FINAL PLAT OF "BLUESTEM ACRES SECOND ADDITION"

RE: SUB 2001-47 -- Final Plat of Bluestem Acres Addition

RE: SUB 2001-47 -- Final Plat of Bluestem Acres Addition

CASE NUMBER: SUB 2001-47 -- BLUESTEM ACRES SECOND ADDITION

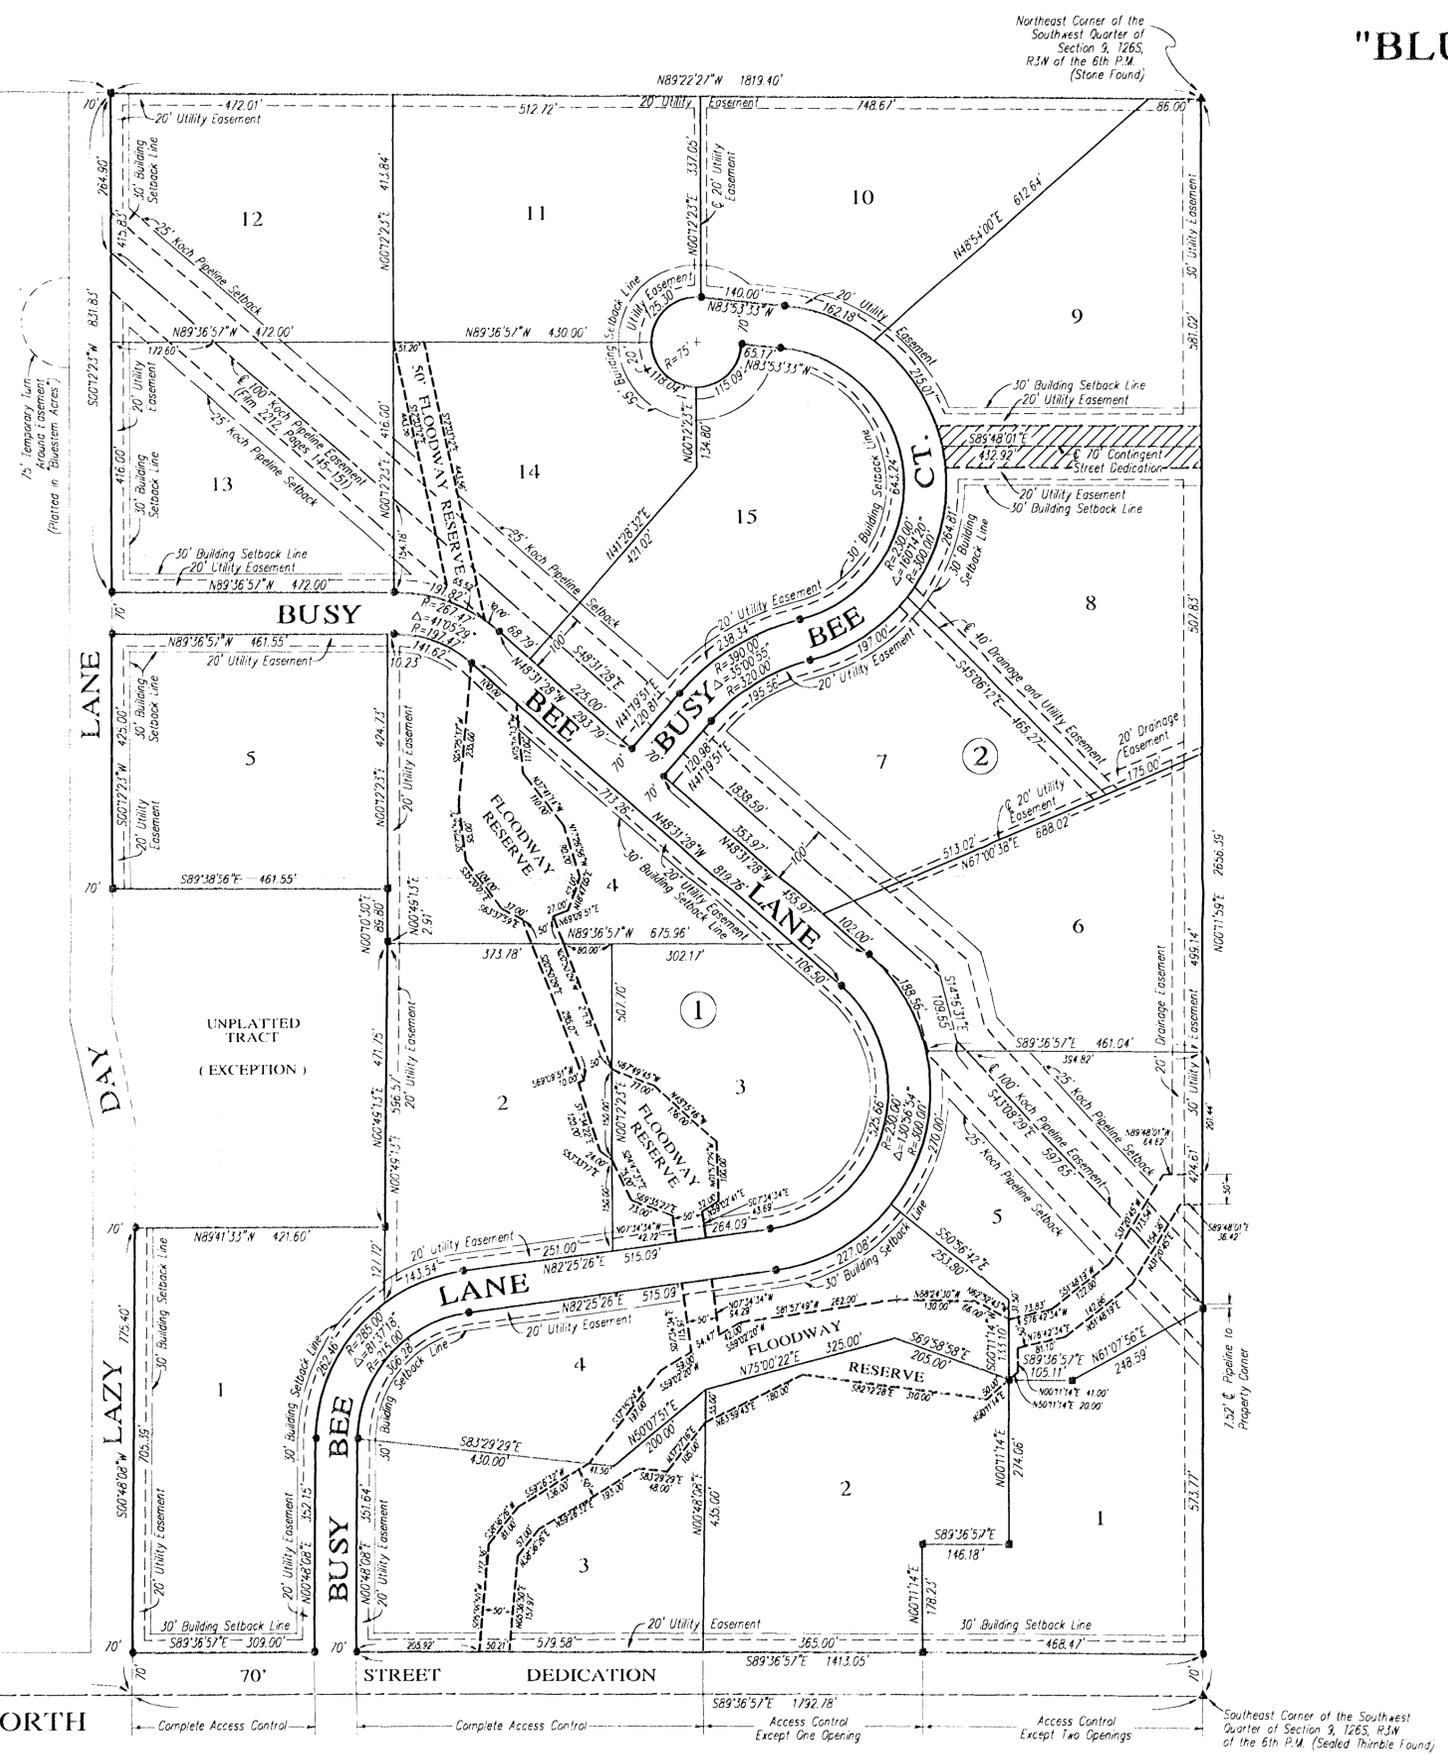
- C. **County Engineering** needs to comment on the status of the applicant's drainage plan. A floodway reserve is needed in Lots 1 through 5, 13 and 14, Block 2, and in Lots 2, 3, and 4 of Block 1. **A lot grading plan is needed.**

- E. The Applicant proposes a 70-ft contingent dedication of street right-of-way extending to the east line of the plat in order to provide potential street connection to adjoining properties. On the final plat, the contingent dedication of right-of-way needs to be referenced in the plat's text as

becoming effective "upon the platting of any adjacent subdivision having a street connecting thereto". The dedication should be labeled as a "contingent street dedication".

- G. The County Fire Department/GIS needs to comment on recommendations for the plat's street names. *Busy Bee Court shall be labeled "Busy Bee Ct."*

- H. The pipeline easement agreements appear to indicate a 25-ft pipeline setback. This setback shall be indicated on the face of the plat and labeled as a Koch Pipeline Setback."

- J. The Subdivision regulations discourage the inclusion of pipeline easements within the perimeter of residential lots. *A restrictive covenant shall be submitted identifying the pipeline within the various lots.*

- L. The plat's text shall include language that a drainage plan has been developed for the plat and that all drainage easements, rights-of-way, or reserves shall remain at established grades or as modified with the approval of the applicable City or County Engineer, and unobstructed to allow for the conveyance of stormwater.

The 30-ft easements have been platted as requested.
